City of Chipley
Planning & Zoning Commission Meeting
May 07, 2026 at 3:00 PM
City Hall - 1442 Jackson Avenue, Chipley, FL 32428
AGENDA

This will approve a Development Order Jack’s Family Restaurant. This property is zoned Commercial and is within the Corridor Development District (CDD) overlay, which requires review and approval by the Planning and Zoning Commission and the City Council. The property is located at 1331 Main Street, Parcel ID:00000000-00-2218-0004, 2.7 acreage.

FROM: Hadley Peterson, Community Planner

DATE: 1/19/26
 SCALE: 1"=20'
 SHEET
C3

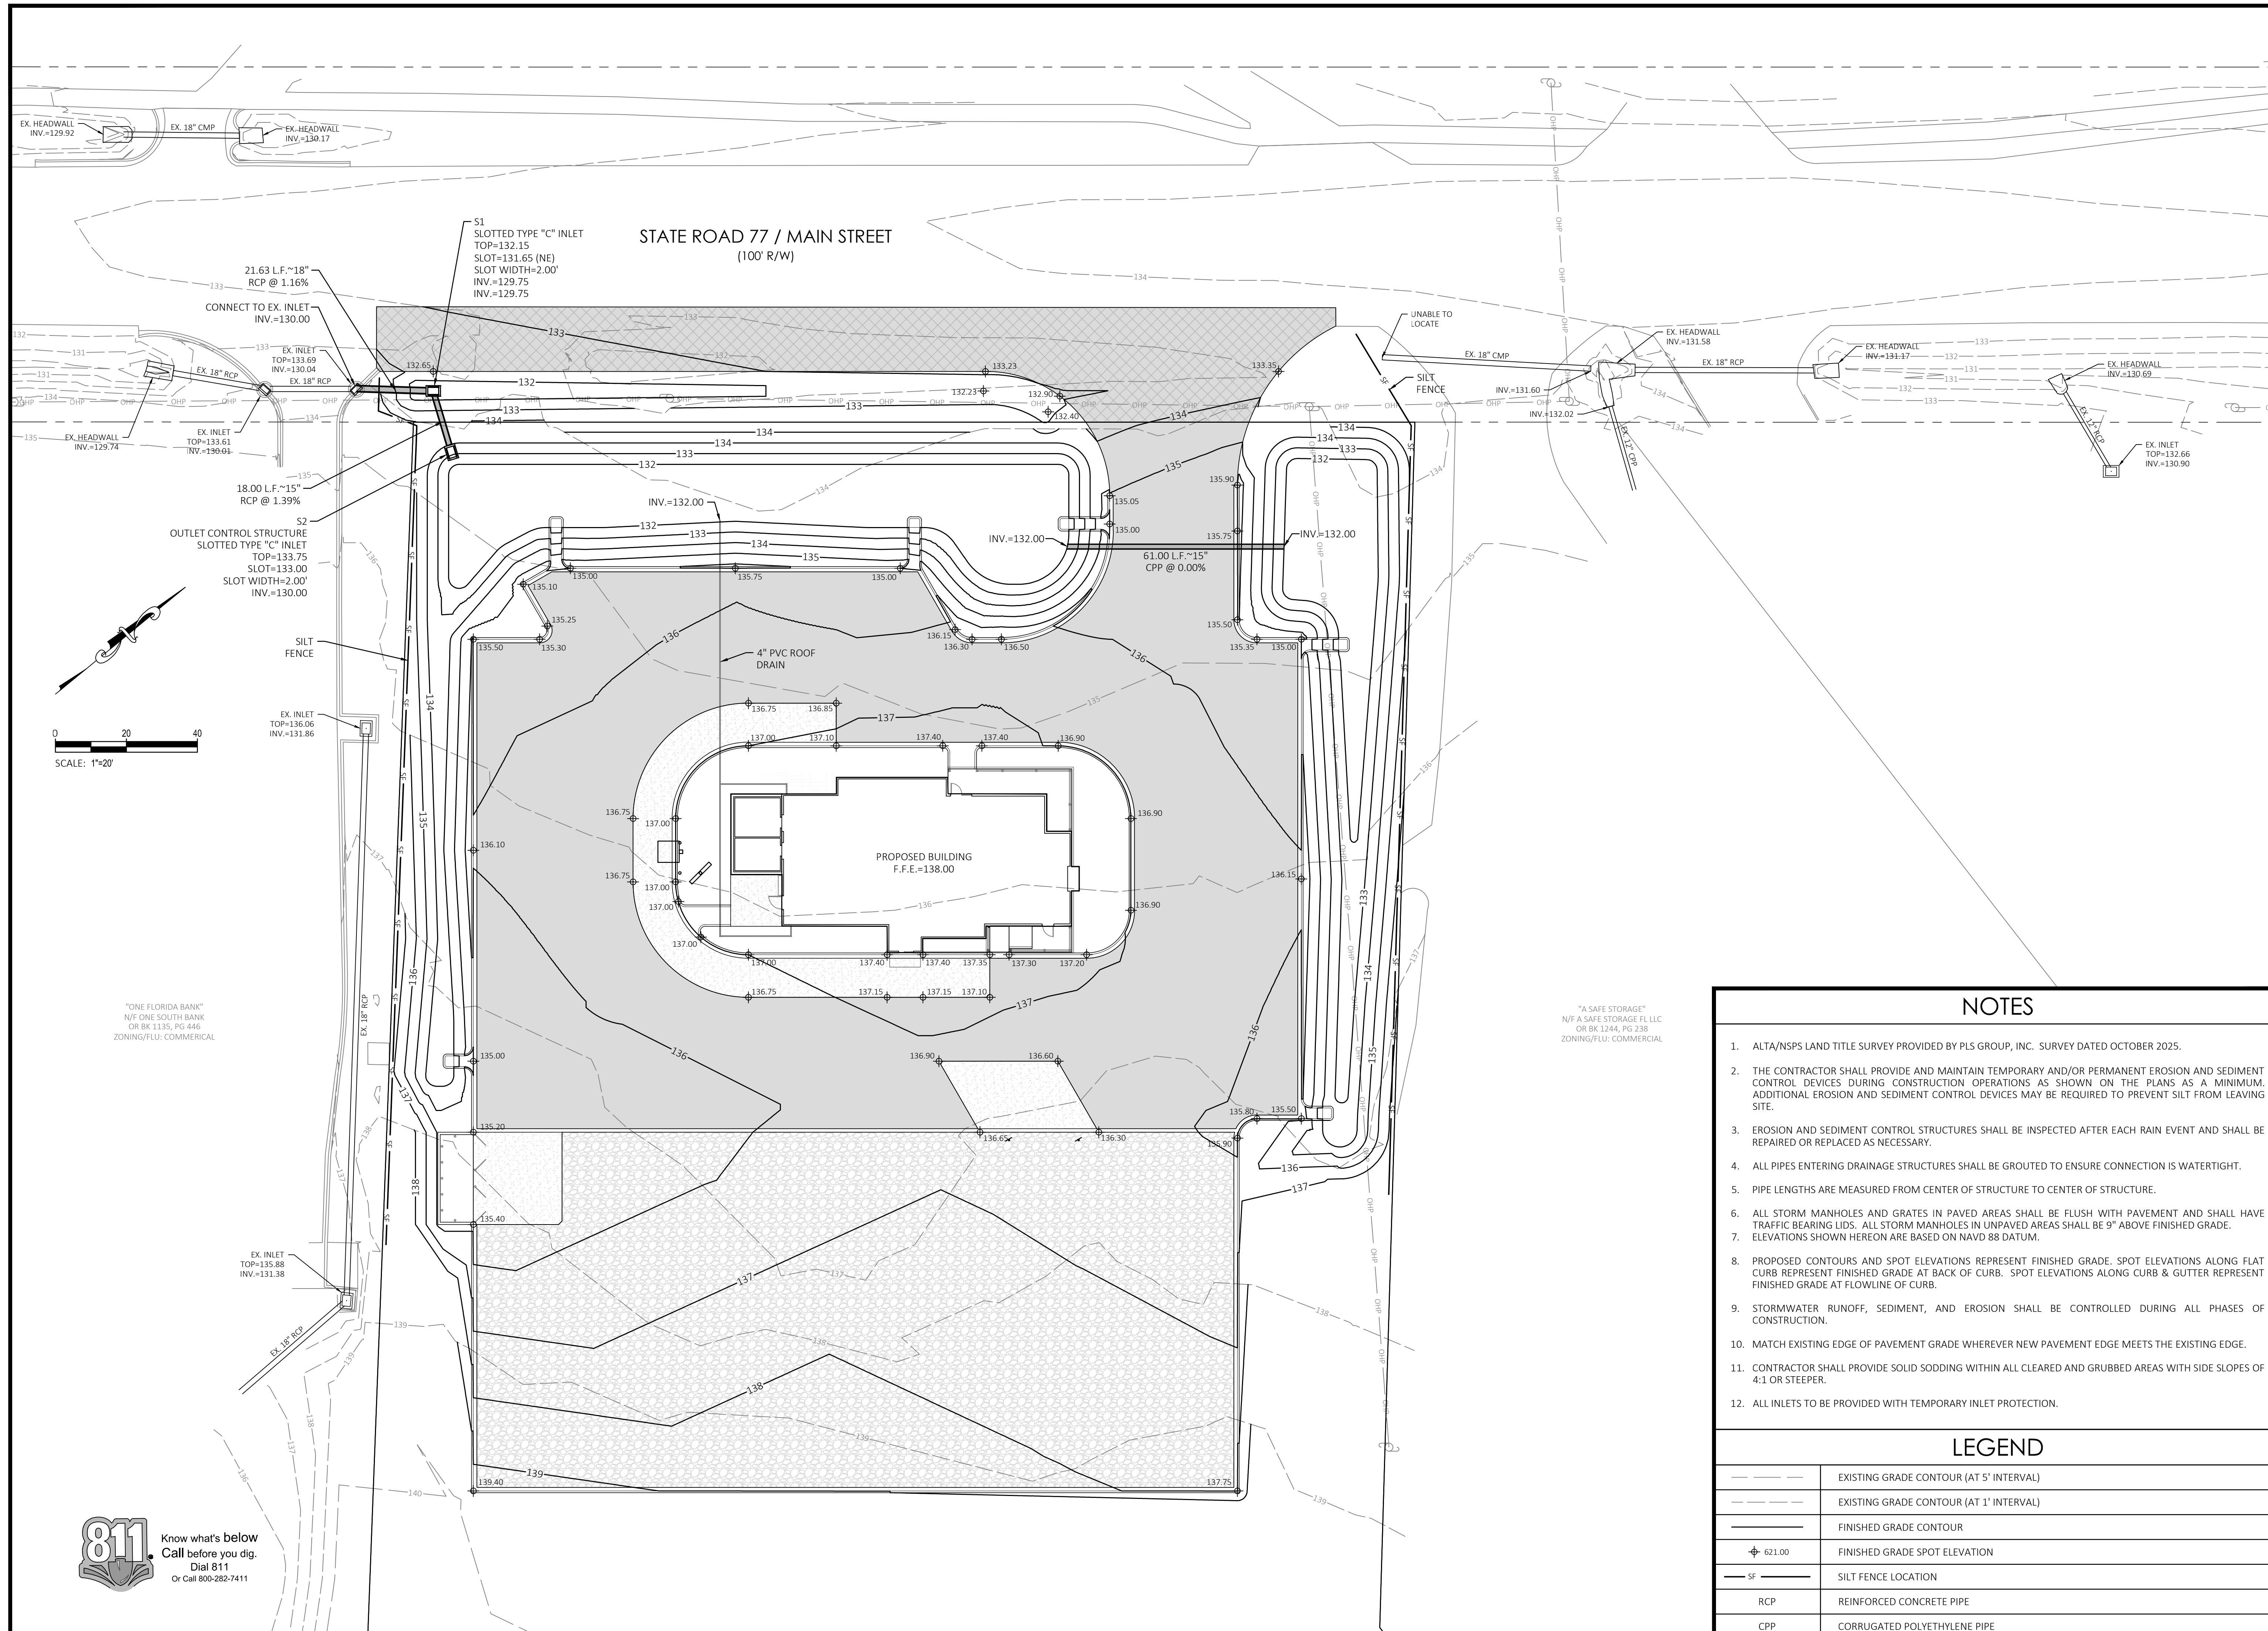
Sufficient: *Provided in Plan Set: Sheets C3, C7 & 01.*
